Re: LETTER FROM MR. F. A. INTIHAR WHICH APPEARED ON THE AGENDA FOR THE OCTOBER 31, 1977 MEETING OF COUNCIL (ITEM 5(f)) PHILLIPS AVENUE/WINSTON STREET INTERSECTION

TO: MUNICIPAL MANAGER
FROM: MUNICIPAL ENGINEER
SUBJECT: LETTER FROM F. INTIHAR REGARDING PHILLIPS AVENUE AT
WINSTON STREET.

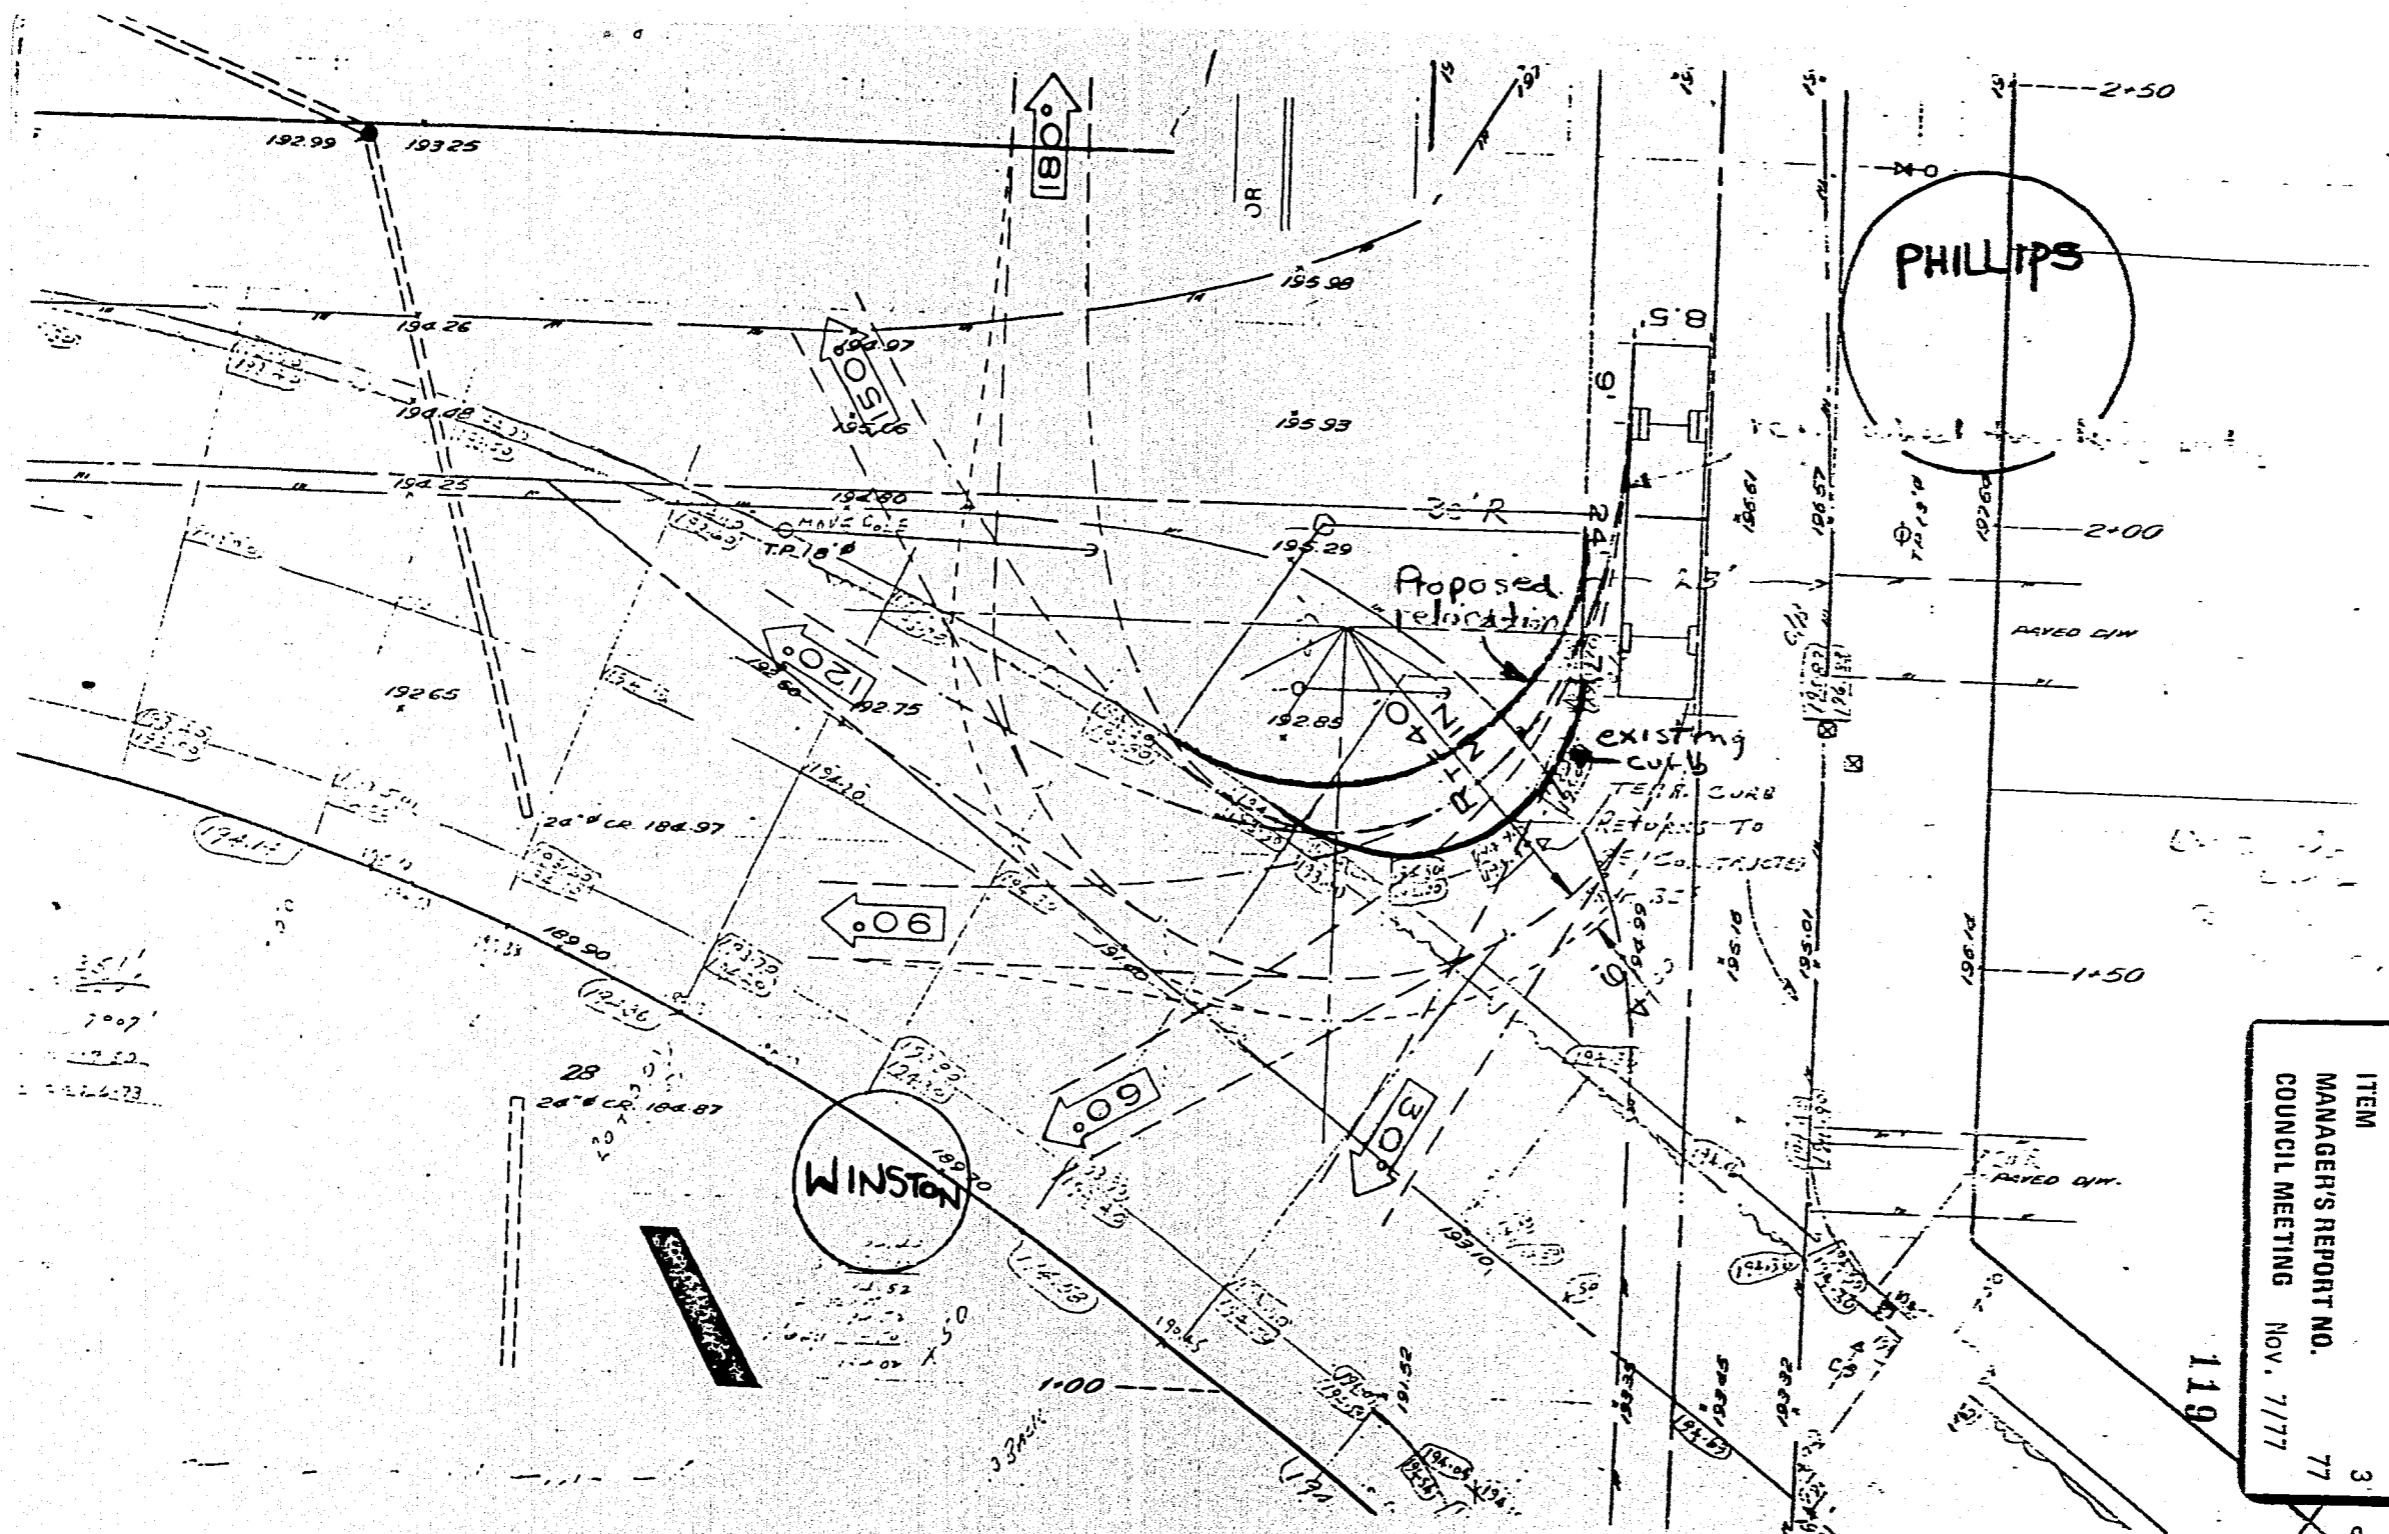
We then made a site visit to the intersection at which time we observed a bus making the maneuver as described by Mr. Intihar, i.e. having to cross the center line on Winston Street in order to turn right from the north leg of Phillips. As this maneuver is unsafe we considered corrective measures, including the proposal suggested by Mr. Intihar. Our decision has been to increase the radius of the curb return on the northwest corner to 30 feet from the existing 20 feet which will permit a bus to make a right turn without either crossing the center line or mounting the curb. A sketch showing this proposal is attached.

The suggested changes submitted by Mr. Intihar were discounted for a number of reasons:

1. The layout as suggested is normally associated with higher speed facilities where it is desirable to have merging traffic accelerate to merge with the highway traffic. Such conditions are not normally desirable on an urban street.
2. A check of our accident records since Winston was built has failed to indicate a single accident involving a southbound Phillips to westbound Winston vehicle.
3. The angle back for the merging driver is approximately 150 degrees.
4. Immediately upon entry onto Winston Street the Phillips Avenue vehicle must make a lane change because of parked vehicles. This could be alleviated somewhat by removal of some parking.

1. THAT Council concur with our proposal to increase the radius of the curb return as a more favourable solution to the described problem.
2. THAT Mr. Intihar be sent a copy of this report.
